AMENDMENTS AND CLARIFICATIONS TO CURRENT DOCUMENTS

The following documents have been published containing minor errors or ambiguities. These are listed below with the amendment/clarification text. Please note that references to these amendments/clarifications have been noted in the Document Titles and Descriptions section of the catalogue under their relative documents.

NEW AMENDMENTS/CLARIFICATIONS

Please see image below which is associated with GIRT7016 amendment text above.

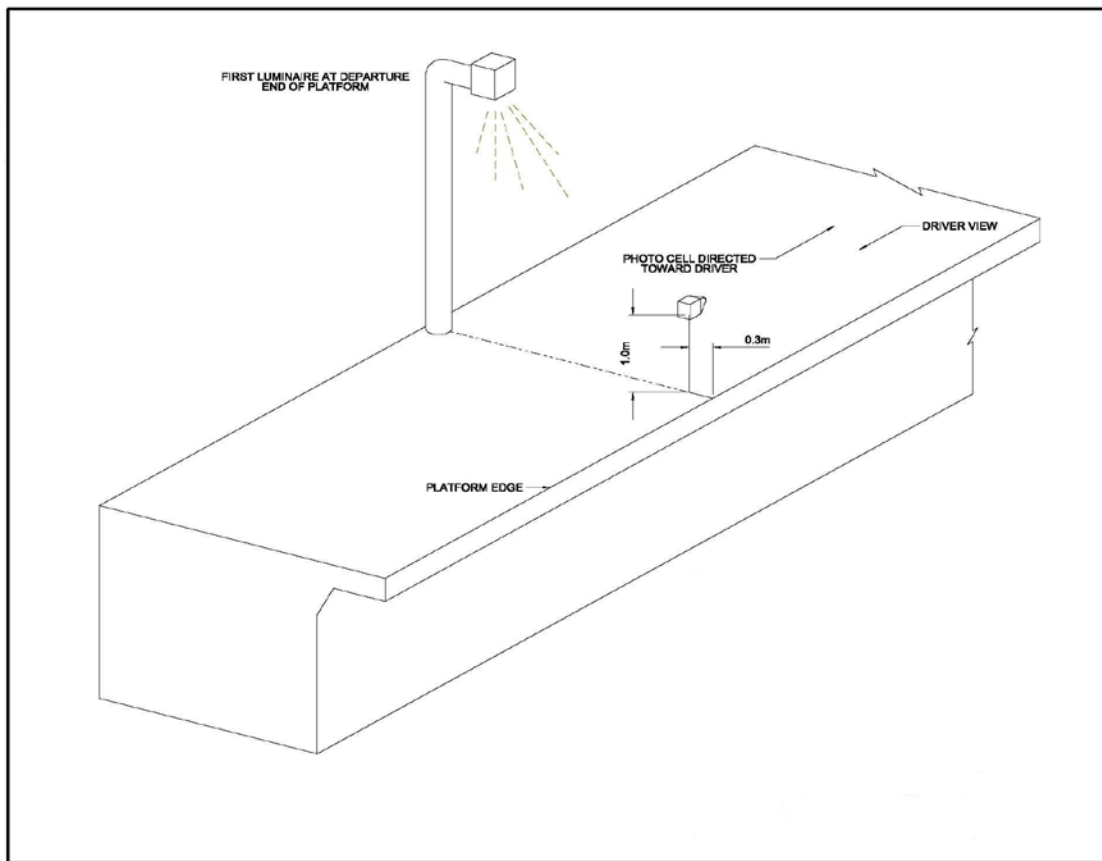
Document number	GI/RT7016	Document issue	3	Document issue date	December 2009
Title:	Interface between Station Platforms, Track and Trains				
Section:	10.3	Clause number	10.3.1, 10.3.2 and 10.3.3		
Amendment text	<p>Vertical plane illuminance towards an observer viewing parallel to the platform edge</p> <p>10.3.1 states that:</p> <p>‘There shall be a minimum illuminance of 2 lux measured vertically at a point 1.0 m above the platform surface and perpendicular to the platform edge.’</p> <p>10.3.2 states that:</p> <p>‘At driver only operation stations (DOO) using mirrors and driver line of sight only, there shall be a minimum illuminance of 6 lux measured vertically at a point of 1.0 m above the platform surface and perpendicular to the platform edge area, along the extent of the platform length to which DOO applies.’</p> <p>10.3.3 states that:</p> <p>‘The required value shall be achieved at a point of 0.3 m back from the platform edge and opposite the first luminaire on the platform. The measurement point should be directed toward the driver or DOO observation equipment.’</p> <p>In relation to the above requirements a clarification in the form of a diagram depicting the first luminaire on the platform is provided to illustrate that the higher illuminance values are required where reliance for safe dispatch is by mirrors, and by line of sight only. Where CCTV cameras and monitors are used, the equipment is required to be suitable for operation at the lower illuminance values, and the cameras will be aimed such that screen contrast is not impaired by glare from luminaires.</p>
